5 COMMONWEALTH PARADE, MANLY

PROJECT
THREE STOREY RESIDENTIAL FLAT BUILDING
WITH BASEMENT CAR PARK AT:

5 COMMONWEALTH PDE,
MANLY, NSW

S4.55 LIST OF AMENDMENTS:

DRAWING TITLE
LEVEL 1 PLAN
 SCALE
 1:100
 @A3
 STATUS
 S4.55
 NUMBER
 A1.02
 REVISION
 s4.55
 PROJECT
 CPM

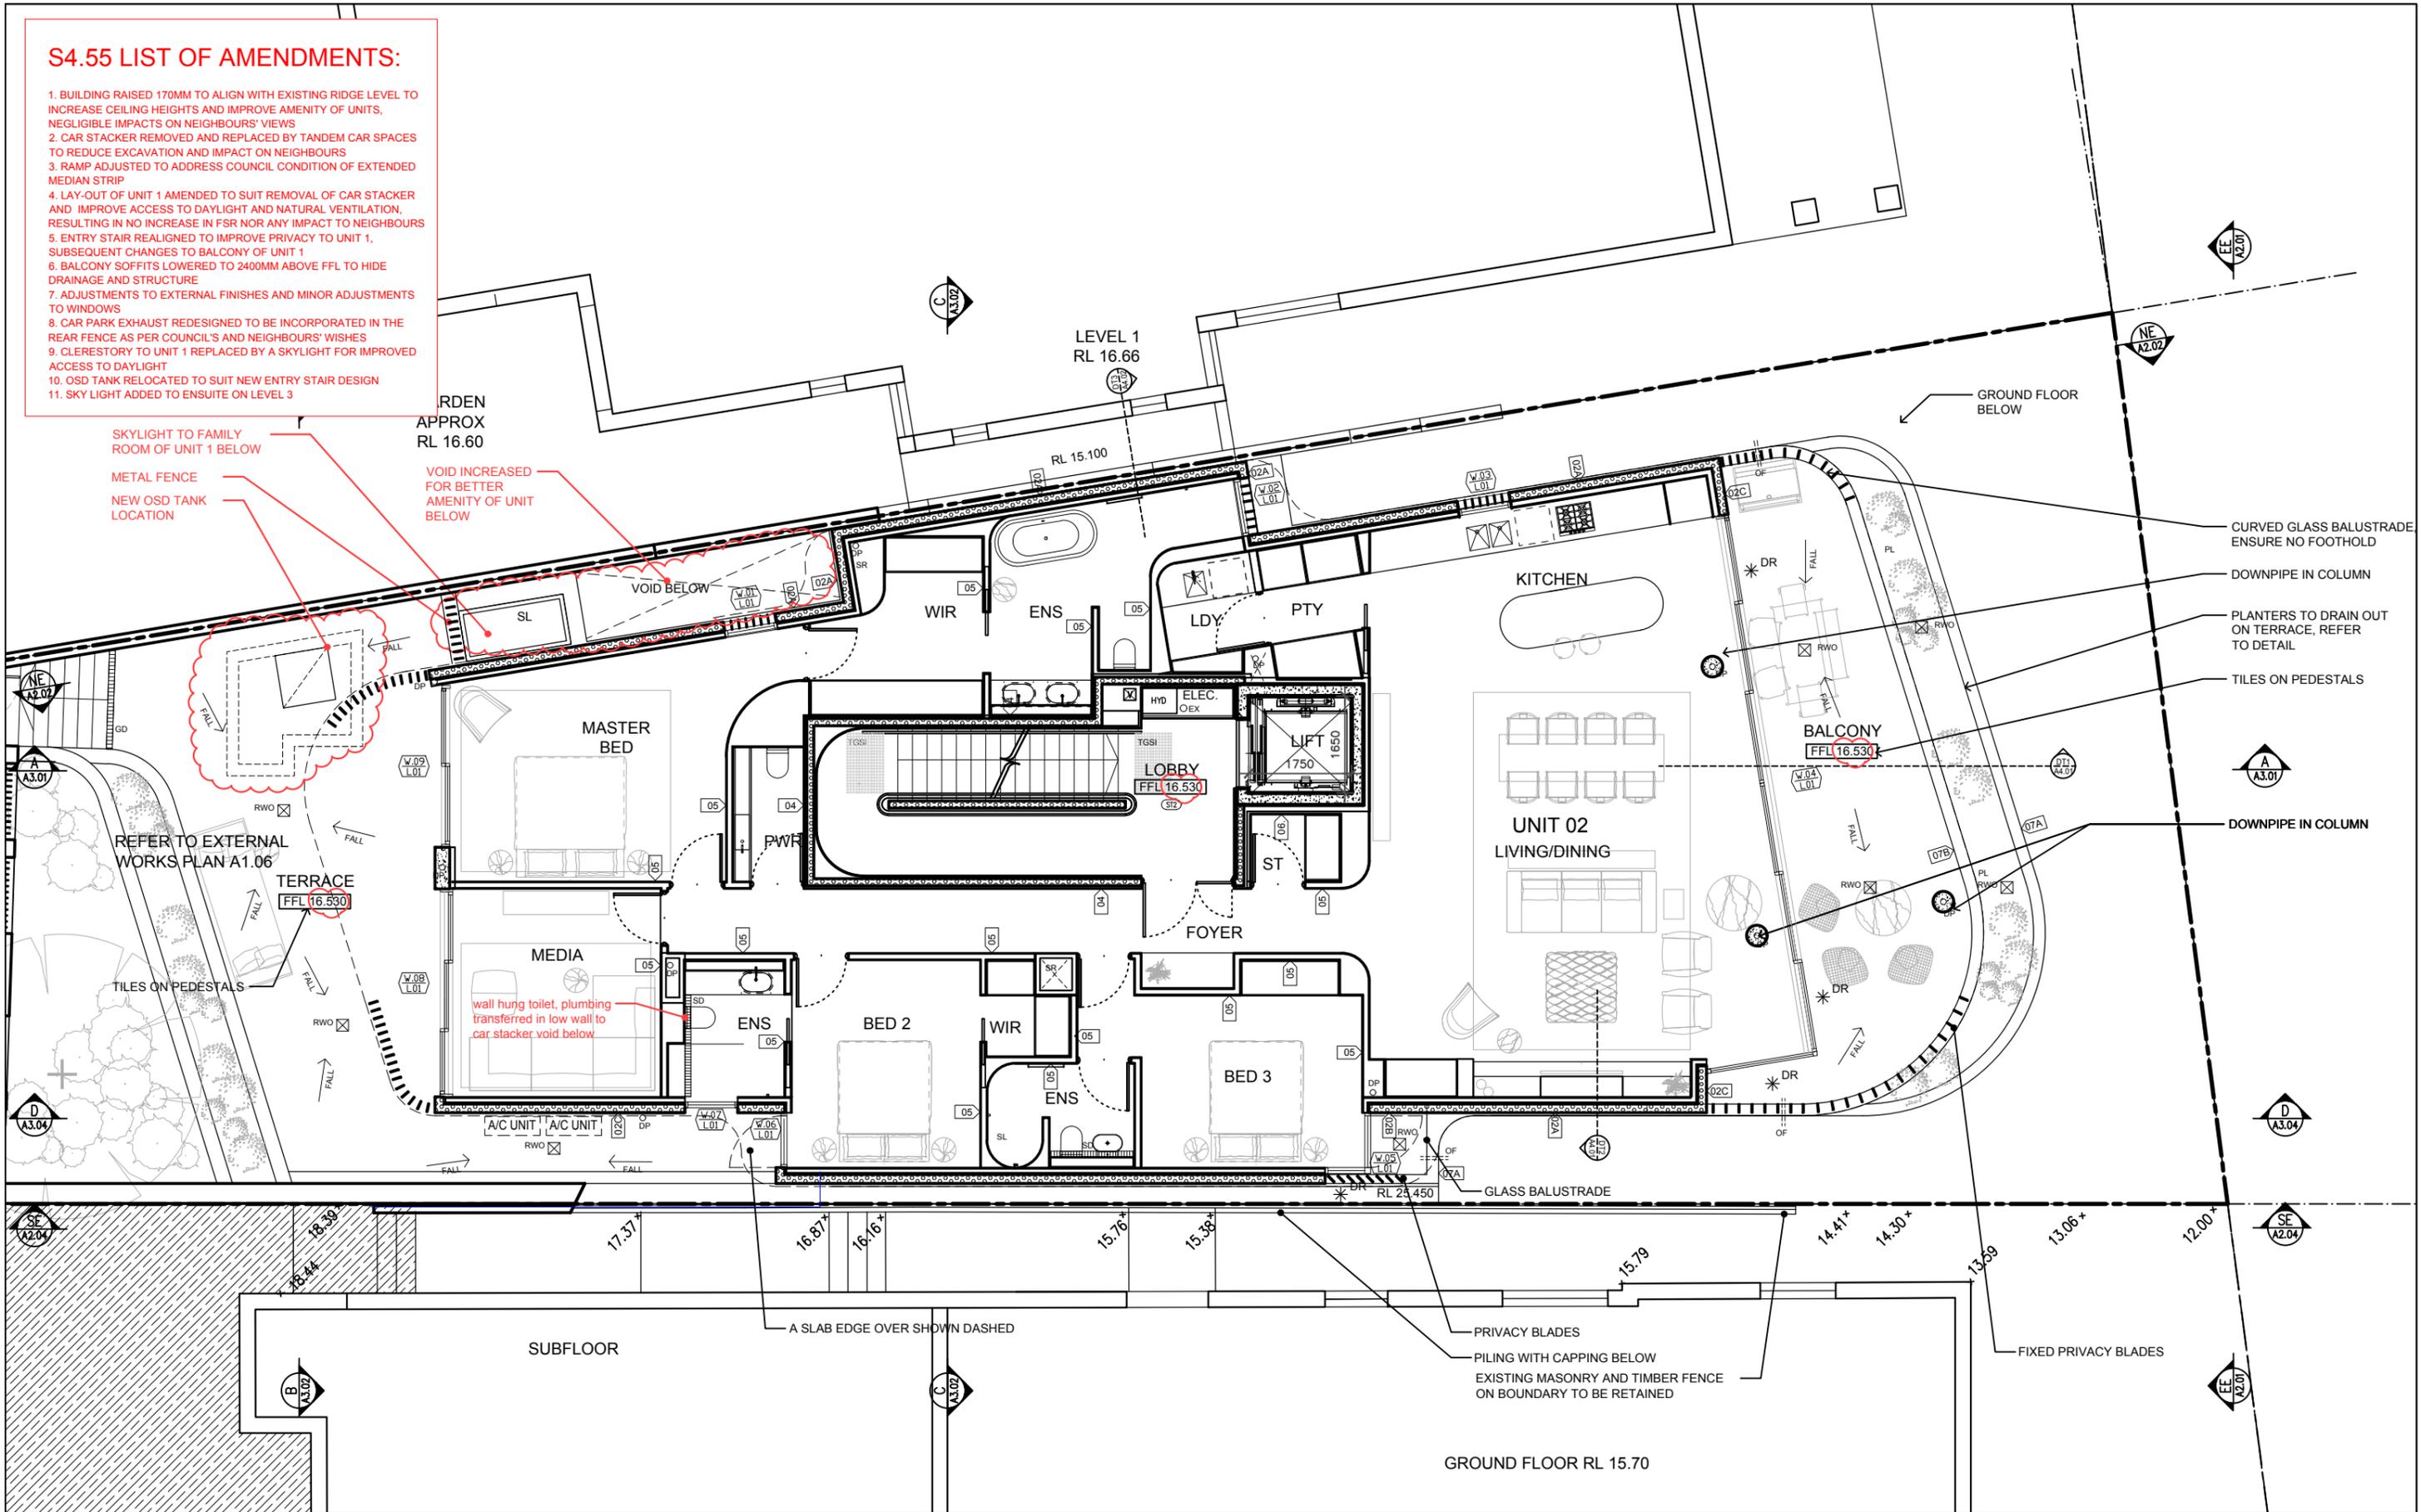
1. BUILDING RAISED 170MM TO ALIGN WITH EXISTING RIDGE LEVEL TO INCREASE CEILING HEIGHTS AND IMPROVE AMENITY OF UNITS, NEGLIGIBLE IMPACTS ON NEIGHBOURS' VIEWS

2. CAR STACKER REMOVED AND REPLACED BY TANDEM CAR SPACES TO REDUCE EXCAVATION AND IMPACT ON NEIGHBOURS
3. RAMP ADJUSTED TO ADDRESS COUNCIL CONDITION OF EXTENDED MEDIAN STRIP

4. LAY-OUT OF UNIT 1 AMENDED TO SUIT REMOVAL OF CAR STACKER AND IMPROVE ACCESS TO DAYLIGHT AND NATURAL VENTILATION, RESULTING IN NO INCREASE IN FSR NOR ANY IMPACT TO NEIGHBOURS

5. ENTRY STAIR REALIGNED TO IMPROVE PRIVACY TO UNIT 1, SUBSEQUENT CHANGES TO BALCONY OF UNIT 1
6. BALCONY SOFFITS LOWERED TO 2400MM ABOVE FFL TO HIDE DRAINAGE AND STRUCTURE

7. ADJUSTMENTS TO EXTERNAL FINISHES AND MINOR ADJUSTMENTS TO WINDOWS
8. CAR PARK EXHAUST REDESIGNED TO BE INCORPORATED IN THE REAR FENCE AS PER COUNCIL'S AND NEIGHBOURS' WISHES

9. CLERESTORY TO UNIT 1 REPLACED BY A SKYLIGHT FOR IMPROVED ACCESS TO DAYLIGHT
10. OSD TANK RELOCATED TO SUIT NEW ENTRY STAIR DESIGN
11. SKY LIGHT ADDED TO ENSUITE ON LEVEL 3

DRAWING TITLE
LEVEL 3 PLAN

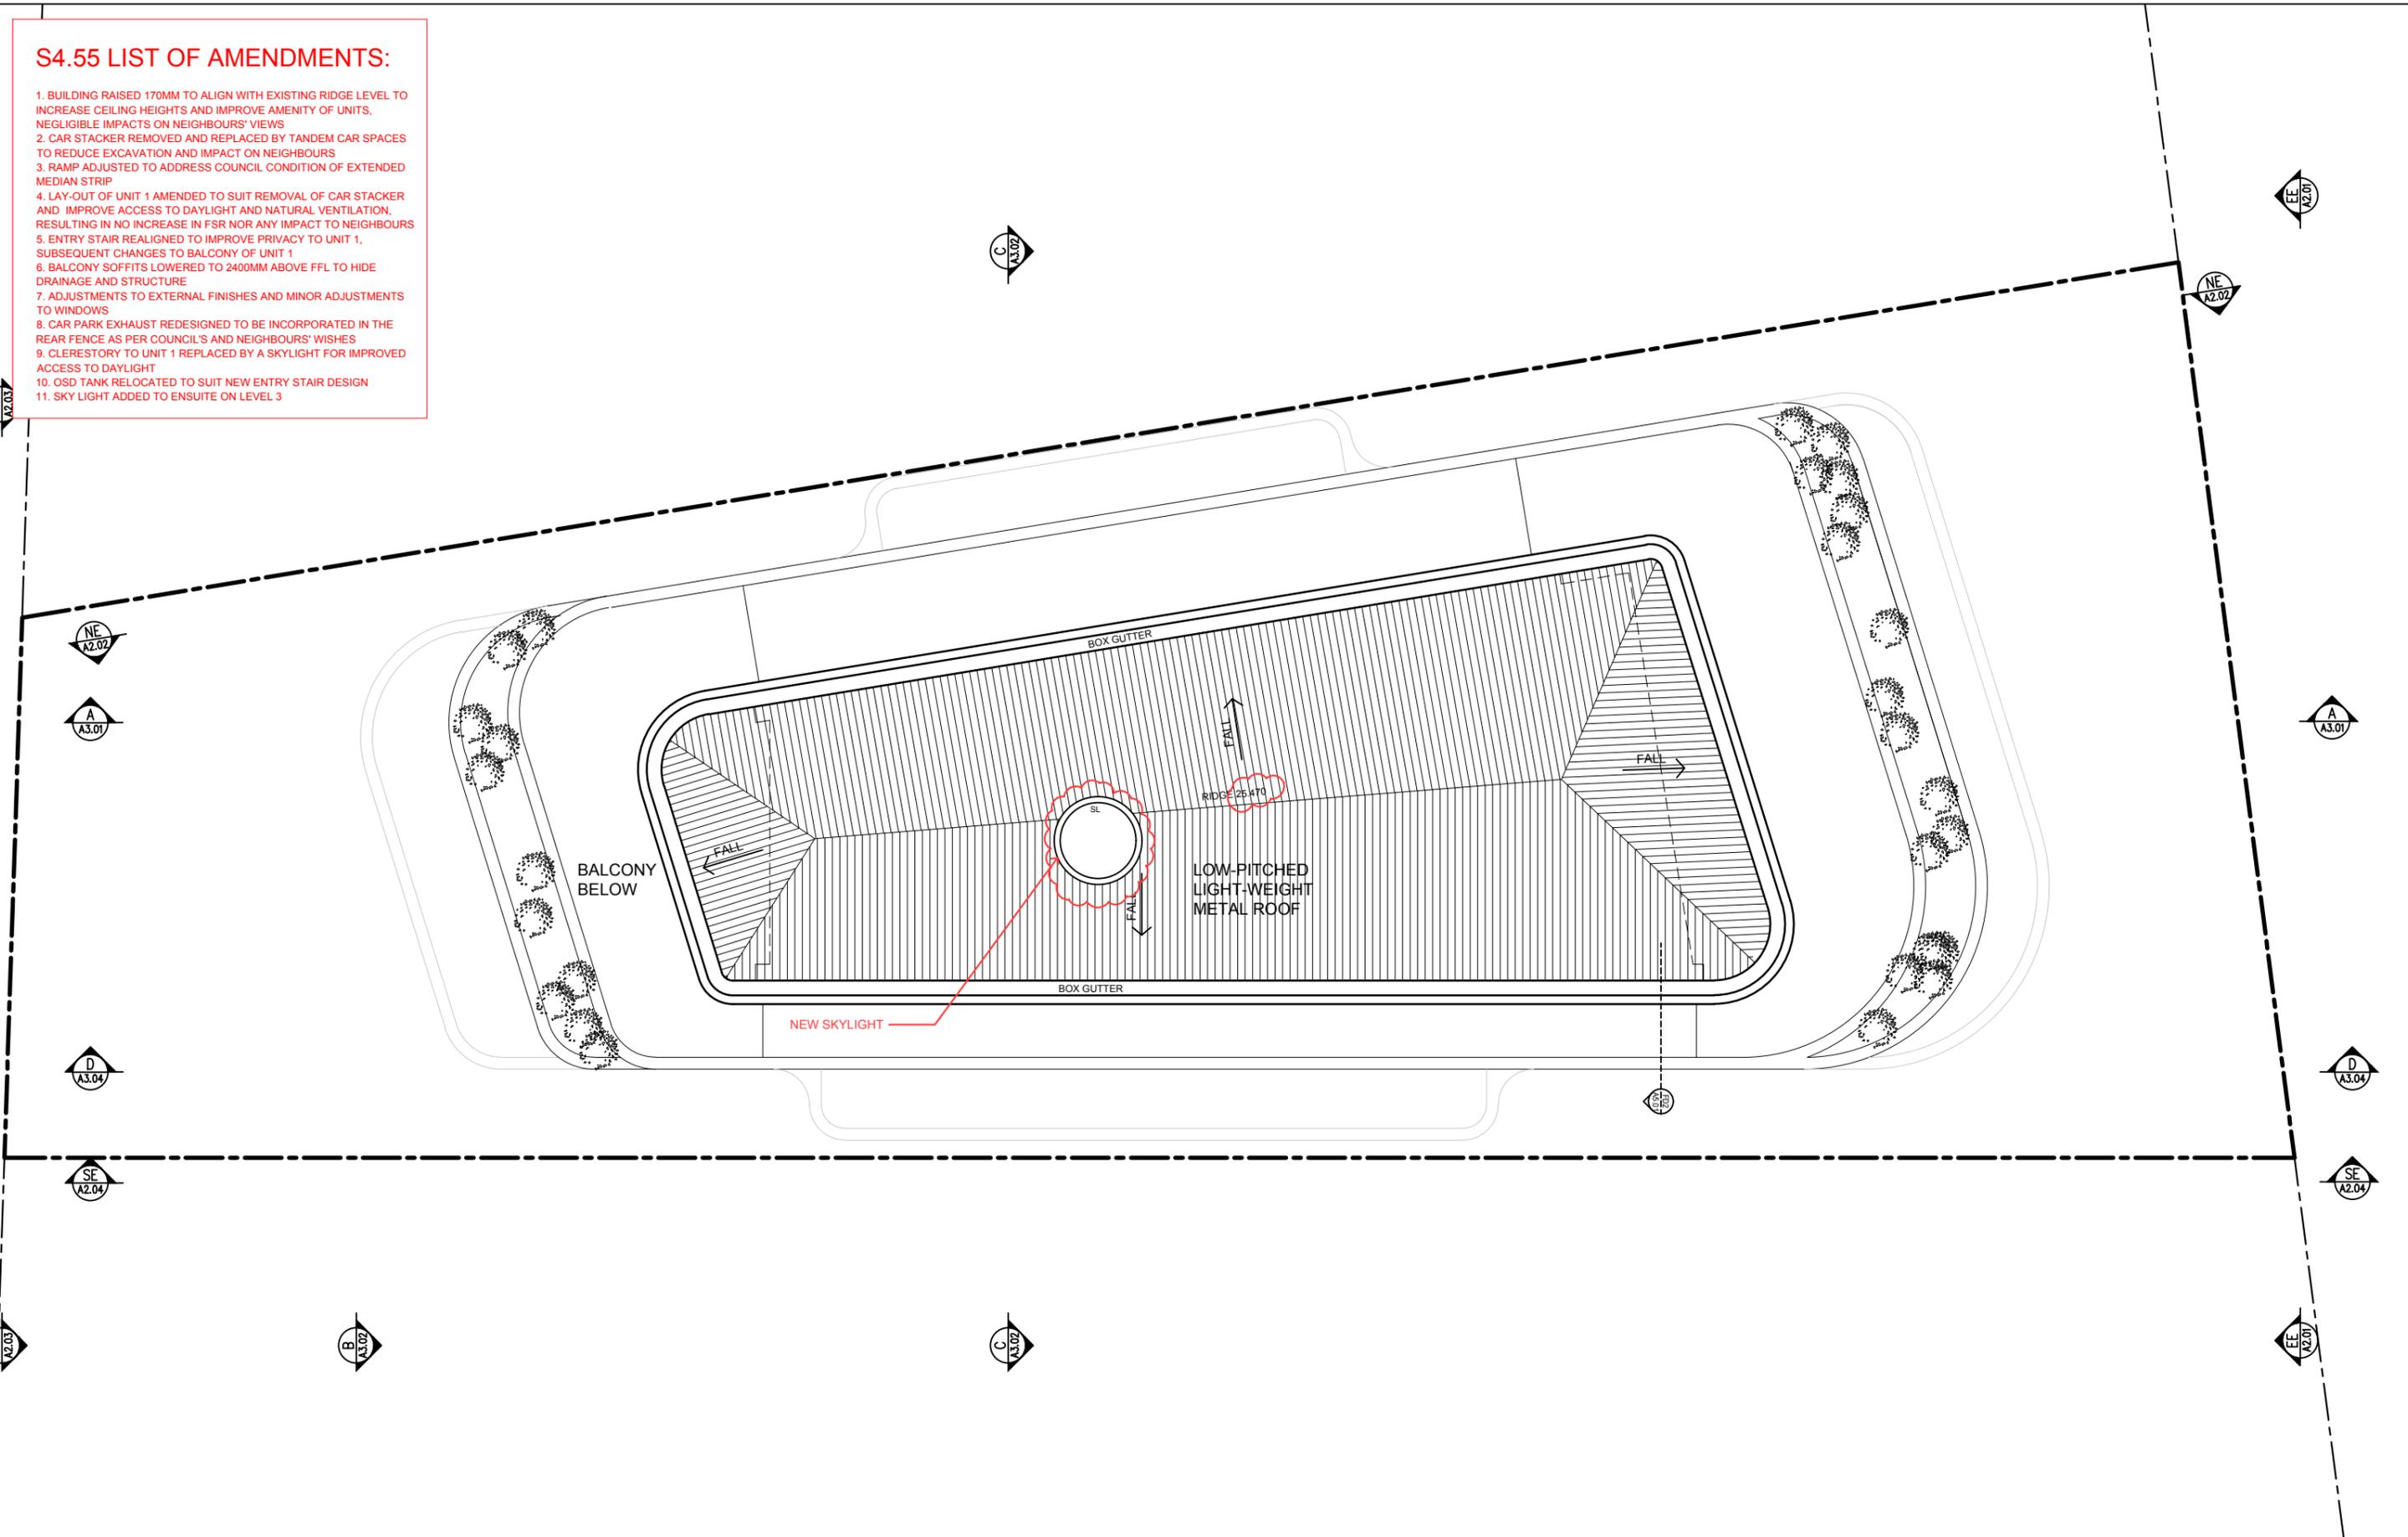
1. BUILDING RAISED 170MM TO ALIGN WITH EXISTING RIDGE LEVEL TO INCREASE CEILING HEIGHTS AND IMPROVE AMENITY OF UNITS, NEGLIGIBLE IMPACTS ON NEIGHBOURS' VIEWS

2. CAR STACKER REMOVED AND REPLACED BY TANDEM CAR SPACES TO REDUCE EXCAVATION AND IMPACT ON NEIGHBOURS
3. RAMP ADJUSTED TO ADDRESS COUNCIL CONDITION OF EXTENDED MEDIAN STRIP

4. LAY-OUT OF UNIT 1 AMENDED TO SUIT REMOVAL OF CAR STACKER AND IMPROVE ACCESS TO DAYLIGHT AND NATURAL VENTILATION, RESULTING IN NO INCREASE IN FSR NOR ANY IMPACT TO NEIGHBOURS

5. ENTRY STAIR REALIGNED TO IMPROVE PRIVACY TO UNIT 1, SUBSEQUENT CHANGES TO BALCONY OF UNIT 1
6. BALCONY SOFFITS LOWERED TO 2400MM ABOVE FFL TO HIDE DRAINAGE AND STRUCTURE

7. ADJUSTMENTS TO EXTERNAL FINISHES AND MINOR ADJUSTMENTS TO WINDOWS
8. CAR PARK EXHAUST REDESIGNED TO BE INCORPORATED IN THE REAR FENCE AS PER COUNCIL'S AND NEIGHBOURS' WISHES

9. CLERESTORY TO UNIT 1 REPLACED BY A SKYLIGHT FOR IMPROVED ACCESS TO DAYLIGHT
10. OSD TANK RELOCATED TO SUIT NEW ENTRY STAIR DESIGN
11. SKY LIGHT ADDED TO ENSUITE ON LEVEL 3
